[MPC Comment] 9-SB-18-C_9-E-18-UR (The Cove in West Hills)

THE COVE IN WEST HILLS

Summary Report of Engineering Study of the Storm Water Management on the Proposed Site of The Cove in West Hills

Submitted to Knoxville-Knox County Metropolitan Planning
Commission April 4, 2018

CONCEPT PLAN & SITE PLAN

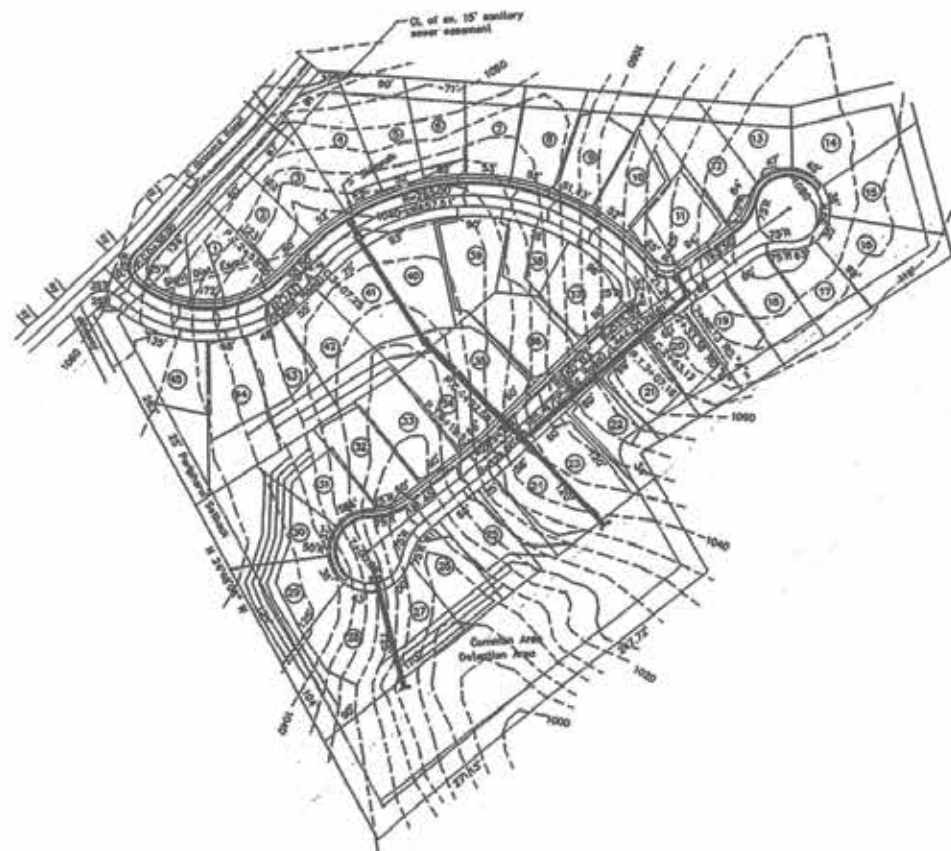
The site plan reflects no details on how storm water management will be accomplished other than the designation of a rectangular area in the southwest corner of the property. WHCA commissioned a professional engineering firm, Geosyntec, in February of this year to conduct a storm water management study when another proposal was under consideration. The study contrasted existing conditions with the then 45-single family houses proposed in this earlier plan. Interestingly, the two site plan street layouts are identical. The later version slightly modifies the steepness of the road profiles and the number of structures changed from 45 to 28 duplex and triplex structures. See attached comparison of site plans. Both proposals can only be executed by clear-cutting the site and removal all old growth trees and existing underbrush which currently mitigate runoff.

FOR CONSIDERATION: The Concept Plan shows a “Common Area/Detention Area” near the low point of the site. The WHCA requests confirmation from the developer that a stormwater basin is intended for this space. If so, the developer must be able to design the stormwater basin in accordance with the guidelines presented herein.

FOR CONSIDERATION: Based on our review of the Concept Plan for The Cove, it does not appear that the following items are depicted:

- A general drainage plan (a general location referred to as “Detention Area/Common Area is shown but it is not confirmed that this location will be used for a sediment basin/stormwater retention pond, and additional drainage information, such as general flow patterns of stormwater runoff and the location of stormwater conveyances planned for the site, are not shown);
- A description of the physical characteristics of the site;
- Locations of existing structures and utilities;
- Existing drainageways;
- A list of required and proposed improvements.

• **Surface Area** - Based on the Concept Plan, it is assumed the **bottom of the basin will be approximately 440 feet by 60 feet** (26,000 square feet or 0.6 acres). The **sediment treatment surface** area, as calculated at the top of the principal spillway would be slightly larger than the bottom area and was calculated to be **450 feet by 70 feet** (31,500 sf or 0.72 acres). This meets the required minimum surface area of 0.56 acres, which was calculated by dividing the 5-year, 24-hour storm event inflow of 56 cfs by 100 (i.e., 1% of the peak inflow for the 5-year, 24-hour storm event).

- **Length to Width Ratio** - The Concept Plan shows two stormwater pipes discharging onto the northwestern and northeastern ends of the basin. **Based on the plan, it does not appear a 4 to 1 length width ratio could be achieved as flow paths would short-circuit the basin.** The developer may modify the plans as their design progresses by constructing baffles, moving the discharge locations, or modifying the shape of the sediment basin.

Based on the Concept Plan for The Cove and the calculations presented above, approximately one acre will be required for use as a sediment basin during construction. It is important to note that this is an approximation of the sediment basin surface area based on the assumptions outlined above, and that other configurations of the sediment basin are possible. Although the area on the Concept Plan that is assumed to be used for the sediment basin (labeled as the “Common Area/Detention Area”) is large enough to accommodate a 1-acre sediment basin, **this does not mean that a sediment basin will be easily constructed in that space.** The developer will need to make additional considerations beyond space requirements regarding the constructability of a basin within the topographic constraints of the site.
